**CITY OF SNELLVILLE
DEPARTMENT OF PLANNING & DEVELOPMENT
PLANNING COMMISSION**

CASE SUMMARY

CASE NUMBER: RZ 19-01 SUP 19-01

DEVELOPMENT/PROJECT: 88-Unit Senior (55+) Apartment Development

The proposed site plan, submitted by the applicant.

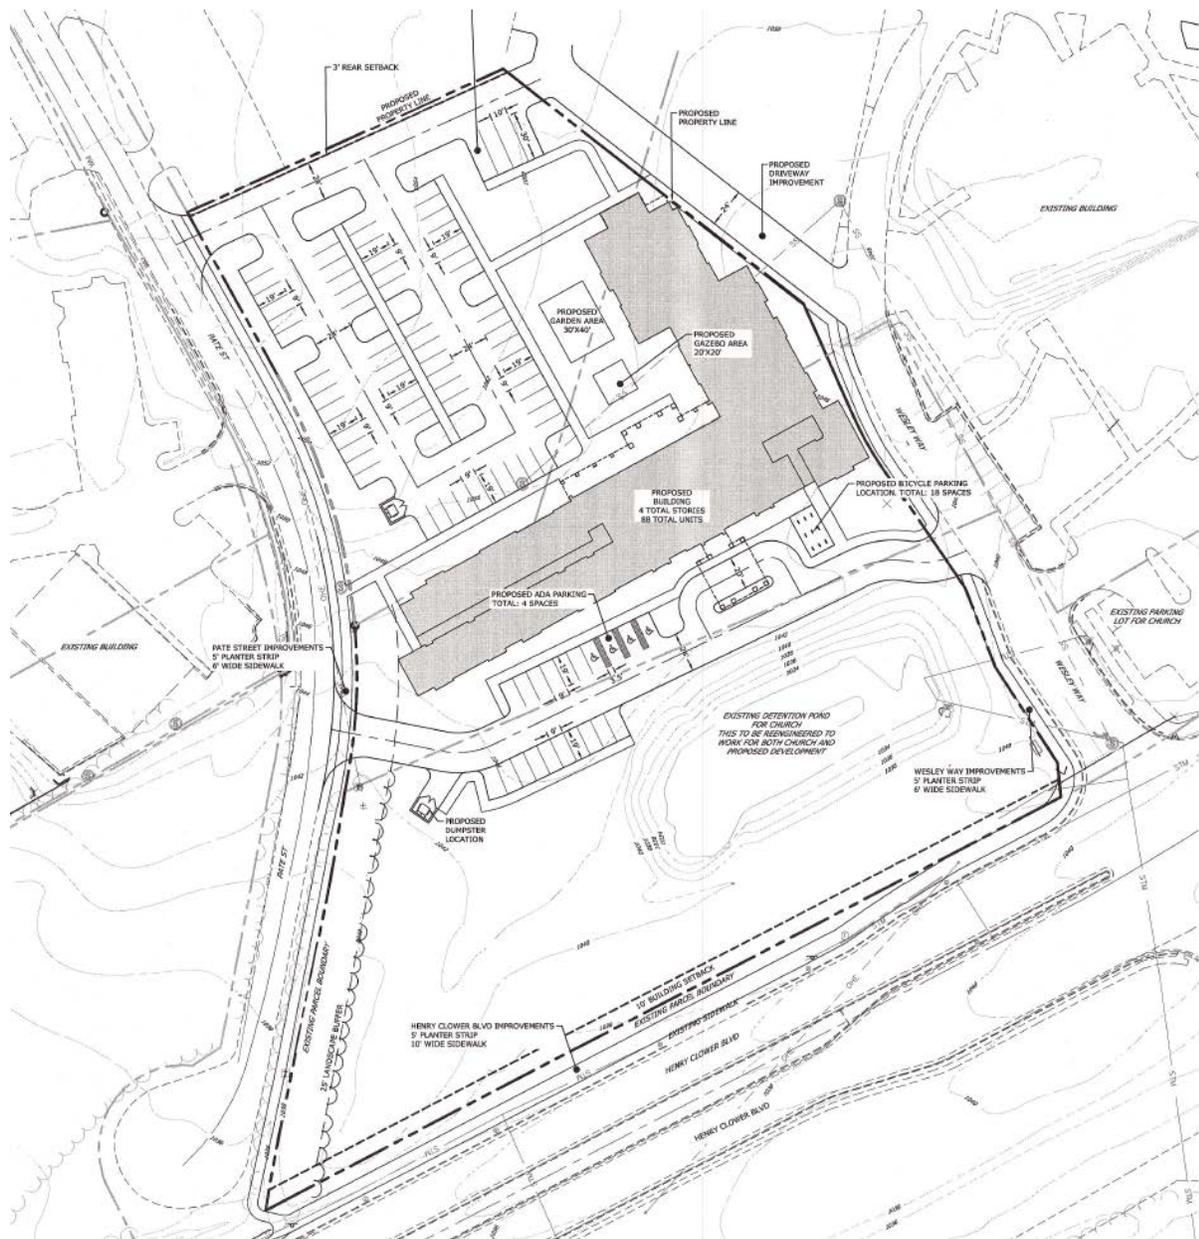
The 4-story, 111,412 sq. ft. "L" shaped building is centered midway on the site, with the main entrance on the south elevation of the building facing Henry Clower Blvd. with full-access drives from Pate Street and Wesley Way. The span of the façade of the south elevation is approximately 310 feet in length, requiring variance approval to exceed the 200-foot maximum façade length in the Towne Center zoning districts. The northeastern building wing, measuring approximately 210 feet in total length, abuts the Wesley Way driveway with a 0-5 feet setback from the five (5) foot planter zone and six (6) foot sidewalk.

Primary parking for the senior apartment development is located to the north behind the building and contains four (4) loading spaces, measuring ten (10) feet wide by thirty (30) feet deep and sixty-eight (68) parking spaces, measuring nine (9) feet wide by nineteen (19) feet deep. A secondary parking area is located between the detention pond and front of the main building wing and contains four (4) ADA handicap spaces and sixteen (16) parking spaces, measuring nine (9) feet wide by nineteen (19) feet deep. A bicycle parking pad is located just right of the main entrance designed to accommodate eighteen (18) bicycles. In total, the applicant is providing eighty-eight (88) parking spaces, equivalent to one space per unit.

There is a 10,938 sq. ft. amenity area located behind the apartment building containing a 20'x20' gazebo area and 30'x40' garden area. Sidewalk connectivity exists internally and around the perimeter of the site except at the northern end of the site near the two full-access drives at Pate Street and Wesley Way. As required by the code, a ten (10) foot wide sidewalk and five (5) foot planter zone is required along Henry Clower Blvd. and a six (6) foot wide sidewalks and five (5) foot planter zone along Pate Street and Wesley Way.

Two solid-waste dumpsters and enclosures are located on the site. The first is located approximately seventy-five (75) feet from the front of the southeast corner of the main building and approximately forty-five (45) feet from the Pate Street R/W. A second dumpster is located behind the main building in the parking area, approximately forty (40) feet from the back of the building and thirty (30) feet from the Pate Street R/W.

There is a twenty-five (25) foot landscape buffer shown on the site plan that extends from the southwest corner of the property and extends north along Pate Street approximately three-hundred-forty (340) feet.

There is an existing stormwater detention dry pond located in the southeast corner of the site that currently serves the SUMC campus. It will be reengineered to accommodate both the SUMC campus and senior apartment site.

Although not shown on the conceptual site plan layout, the development shall be required to meet the Landscaping and Screening requirements of Sec. 9.23(T) of the Zoning Ordinance, as well as the Buffer, Landscape and Tree Ordinance of Chapter 19 of the City Code, as applicable.

1. The property shall be developed according to the proposed site plan entitled “Conceptual Site Plan Layout United Methodist Church Wendover Group”, sealed and dated 3-7-2019 with modifications permitted due to engineering restraints, ingress and egress, and/or to meet conditions of zoning or State, County, and City regulations;
2. New signs higher than 15 feet or larger than 225 square feet are prohibited;

3. Dumpsters to be serviced/emptied no earlier than 9:00 a.m. or later than 6:00 p.m. (M-F only);
4. Continuation of a six (6) foot wide sidewalk shall be required along the property line to the north, between the Pate Street and Wesley Way ingress/egress drives;
